INDESIT company

Model type:
LL64XEU

Commercial code:
F029546

Notices

N1045072FIG1

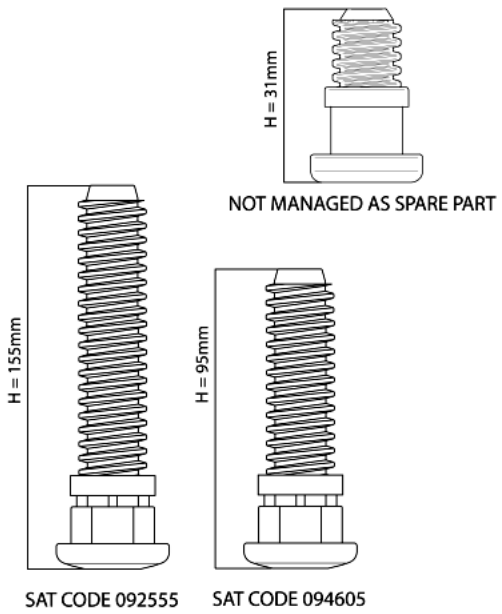
N1045072: Introduction of fixed rear foot H=31mm on free-standing models.

From serial no. 40218.0001, free-standing dishwashers affected by this modification have been equipped with new fixed rear feet (H=31mm).
The new foot replaces the adjustable one (H=155mm) Service code 092555; on the EVO3 range with TurboDry the new foot replaces the adjustable foot (H=95mm) Service code 094605.
The Spare Part Warehouse will continue to manage only 155mm and 95mm adjustable feet as they are interchangeable with the fixed 31mm foot.
The three feet are shown in illustration N1045072FIG1.

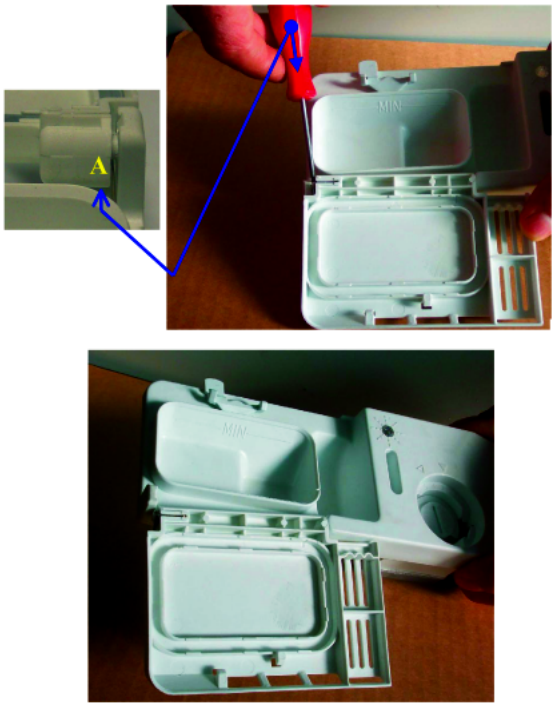
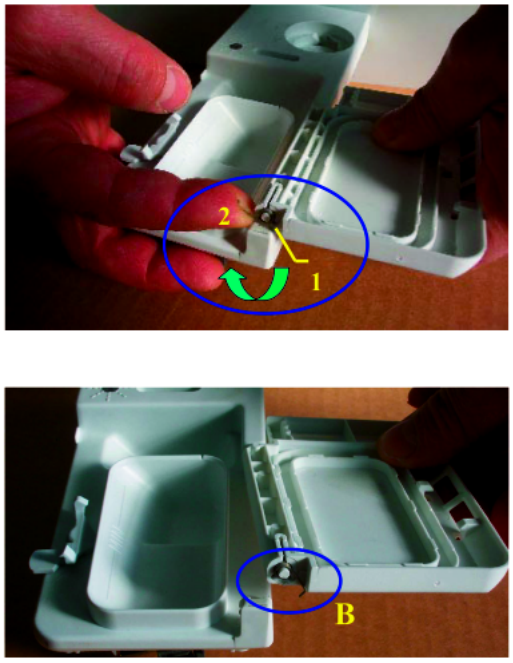
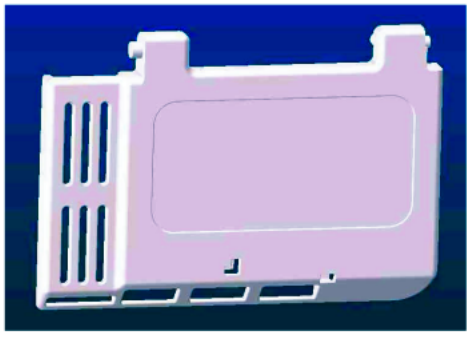
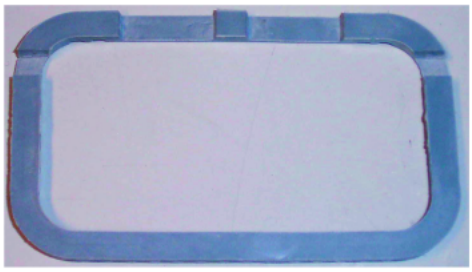
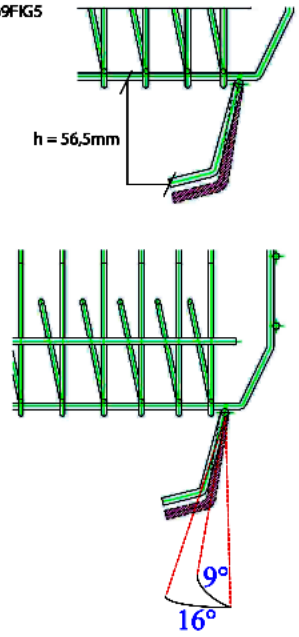
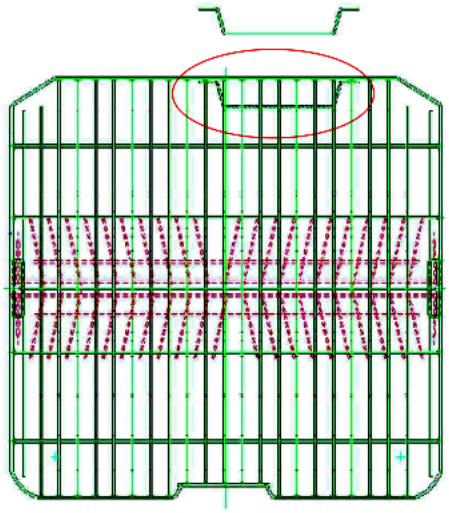
n1045069: Modification of racks and dispenser lid on EVO3 dishwashers

To obtain better dissolving of the detergent during the wash cycle, the following modifications have been made to EVO3 dishwashers:
- new dispenser lid, replacement code 098134 (see figure N1045069FIG4) created;
- upper racks modified with lid catch angle changed from 9° to 16° (see figure N1045069FIG5);
- MultiSystem lower racks modified with insertion of a spacer wire at the electric dispenser (see figure N1045069FIG6).

Lid installation instructions:
1) prise the lid out of the dispenser seat using a small screwdriver at point A (figure N1045069FIG1);
2) replace the lid, checking that release spring B (figure N1045069FIG2) is in place; before fitting the new lid load the spring from position 1 to position 2 (figure N1045069FIG2);
3) fit the lid in its special seat and check for correct operation (figure N1045069FIG3).
Lid closing may be harder for the first few cycles after replacement, due to settling of the material.

The upper and lower racks have the same spare part codes as the premodification items; Replacements Warehouse stocks have been replaced.

N1045080FIG1

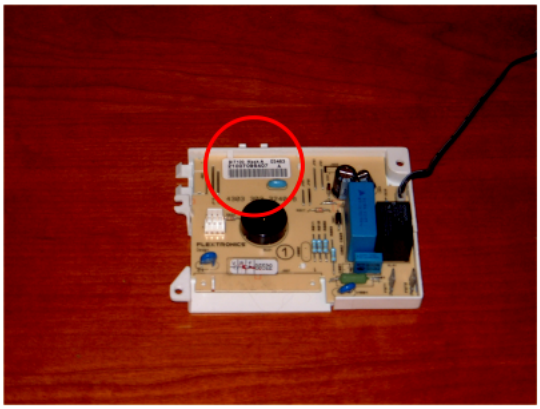
n1045080: Modification of front feet on free-standing DW.

From serial no. 40413.0001, free-standing dishwashers affected by this modification have been equipped with new front feet Service code 109991 in place of 056414.
The new foot is shown in fig. N1045080FIG1.

N1045083FIG1

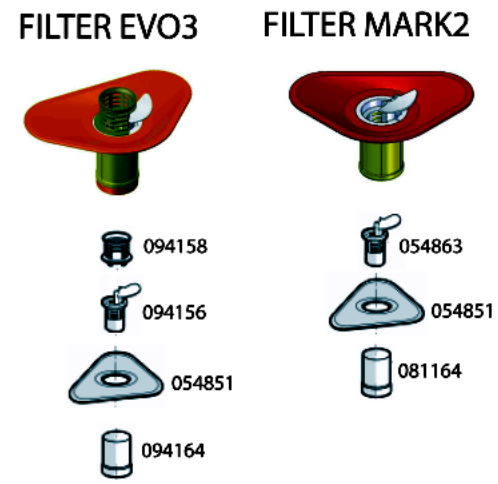
n1045083: Modification of filters on EVO3 60 cm dishwashers

All dishwasher models affected by this modification have been equipped with the items listed below, in order to solve the drain pump clooging problem.

Introduction of:
Cylindrical plastic filter code 081164
Central filter code 054863

Elimination of:
Cylindrical plastic filter code 094164
Central filter code 094156
Central filter grid code 094158

The modification has been introduced progressively, starting from serial no. 40516.0001.

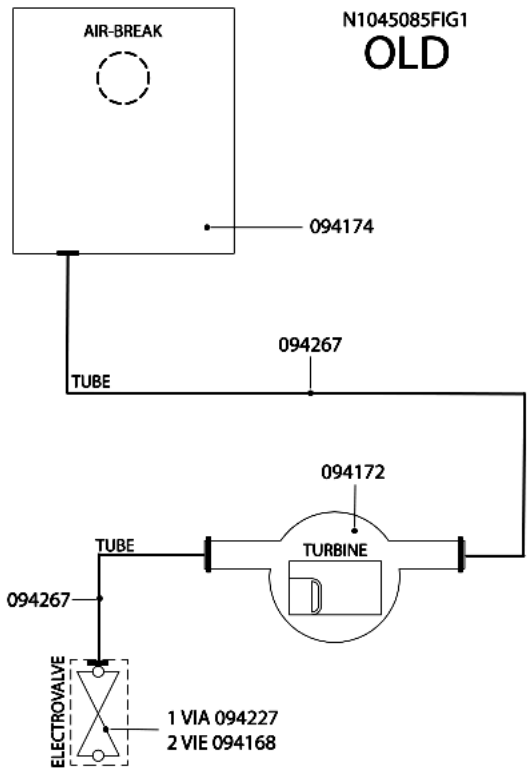
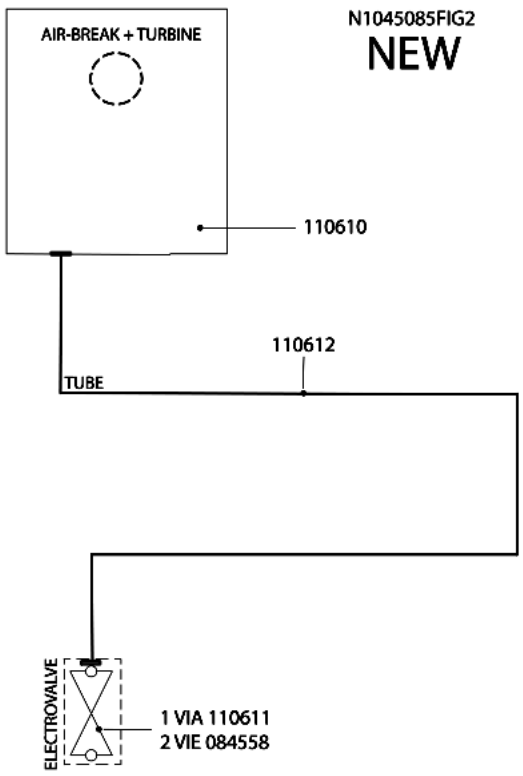
n1045085: Introduction of new litre counter turbine integrated on air-break.

All dishwashers affected by this note have been equipped with a new litre counter turbine on the air-break.
Picture N1045085FIG1 illustrates the premodification structure, picture N1045085FIG2 the new structure.

AIR-BREAK:
new 110610;
premodification 094174;
the new item features a new integrated litre counter turbine and its water supply hose has a smaller diameter.

SOLENOID VALVES:
new:
1-WAY code 110611;
2-WAY code 084558(Rohs 143737);
premodification:
1-WAY code 094227;
2-WAY code 094168;
the new solenoid valves have a smaller diameter drain hose fitting.

HOSES:
new solenoid valve hose/air-break code 110612;
premodification turbine hose/air-break code 094267;
premodification solenoid valve hose/air-break code 094267;
the new hose has a smaller internal diameter.

N1045093FIG1
NEW FLAP UPPER BASKET SAT CODE 114799

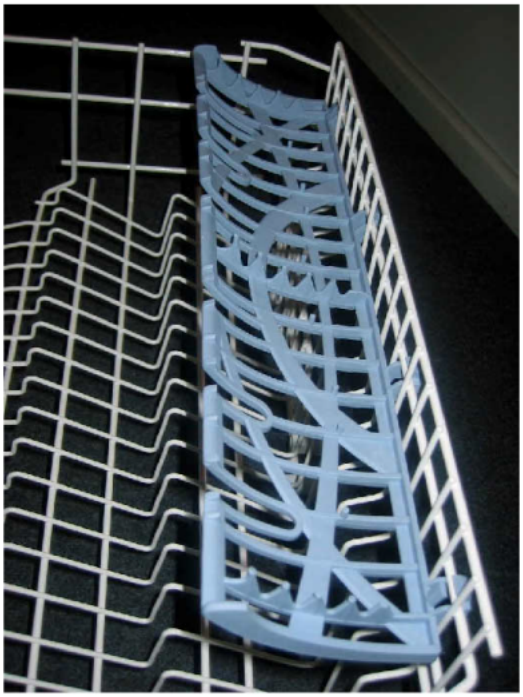
n1045093: Modification of light blue folding shelf attachment.

From serial no. 41109.0001 all models affected by this bulletin feature a modification of the folding shelf to upper basket coupling system.
This modification called for alteration of the relative baskets: the distance between the wire on which the folding shelf is attached and the wire below it has been increased from 9.5 mm to 17 mm, as shown in the attached image.
The altered folding shelves are not interchangeable and cannot be installed on premodification baskets: in the case of service interventions on product with serial number prior to 41109.0001 the entire upper basket must be replaced.
The baskets are reciprocally interchangeable and are managed as assemblies complete with their accessories, inclusive of folding shelves.

UPPER BASKET LIGHT BLUE FOLDING SHELF
new 114799 - premodification 094140.

UPPER BASKET ASSEMBLIES
new 115001 - premodification 094139;
new 115002 - premodification 094222;
new 115003 - premodification 094233.

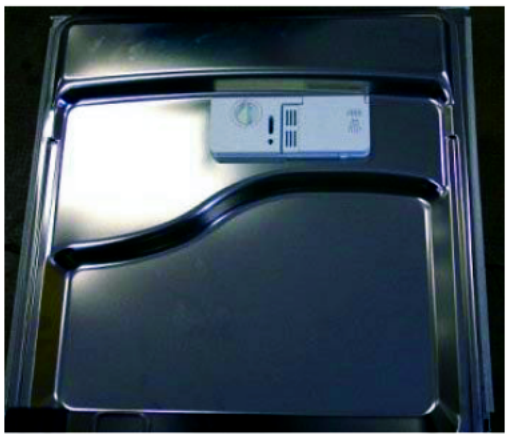
n1045119: Different position of electric distributor.

The position of the electric distributor has been changed as shown in the attached illustration.
The new machines have a new industrial code.

Introduced items:
C00119426 upper rack
C00108981 inside door
C00109858 internal door sound-proofing panel
C00109857 internal door spacer

Premodification items:
C00115001 upper rack
C00094695 inside door
C00097501 internal door sound-proofing panel
C00094147 internal door spacer

Cod. 16001696000

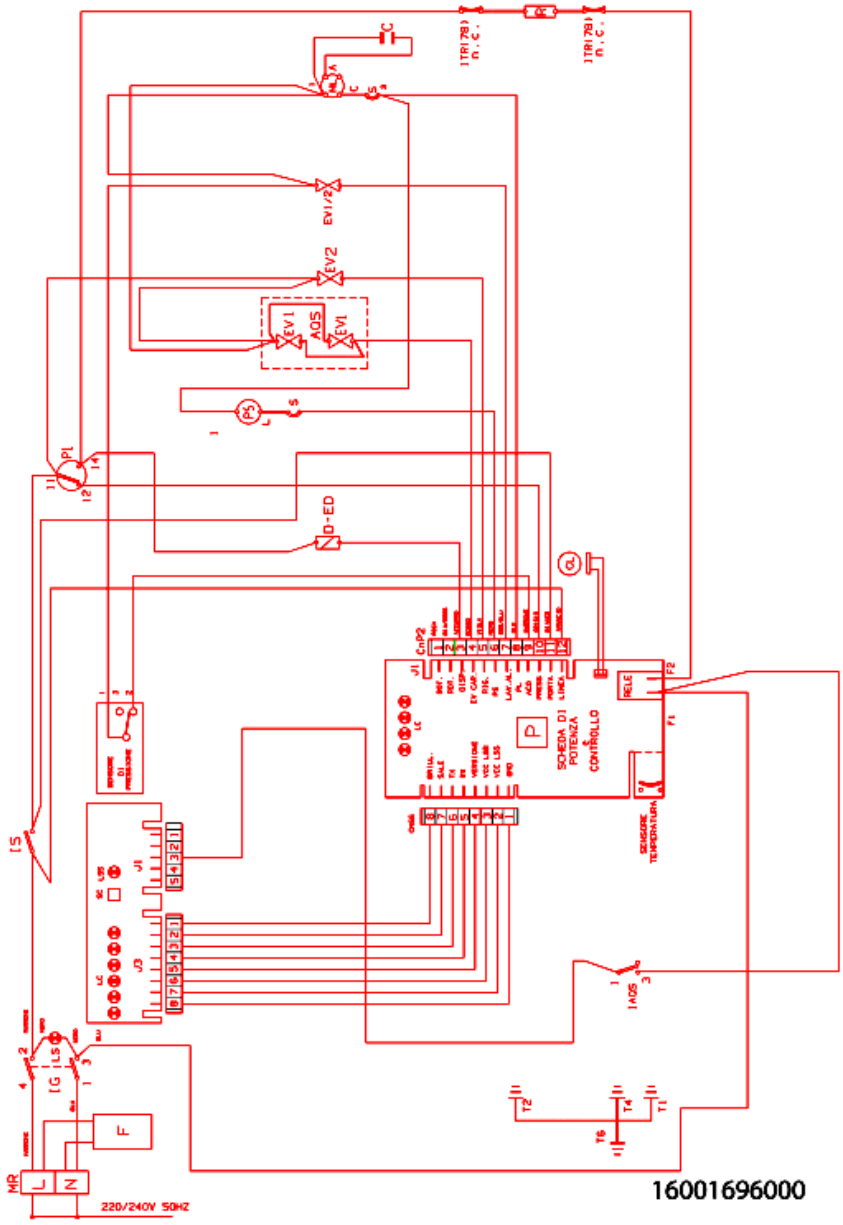
n1045070: Introduction of 1/2 load control with BIT 100 timer by means of solenoid valve.

EVO3 dishwasher models affected by this modification have been equipped with the new BIT 100 timer, in place of the alternating wash motor, that controls the 1/2 load system by means of a solenoid valve located on the volute of the electric pump.
Modified items:
- electric pump code 088896(W45V220P20) replaced with 077140(W75V220P24);
- electric pump code 088888(W45V240P20) replaced with 080512(W75V240P24);
- volute code 088889 replaced with 054979;

- BIT 100 timer code 094686 replaced with 097431;
- alternating wash motor code 077172 replaced with half load solenoid valve code 054985.

LL64XEU Commercial Code 29546 Serial no. 31030.0001 ;
Wiring: new 098827 premodification 094130 ;
Wiring diagram: new 16001696000 premodification 16001626801.
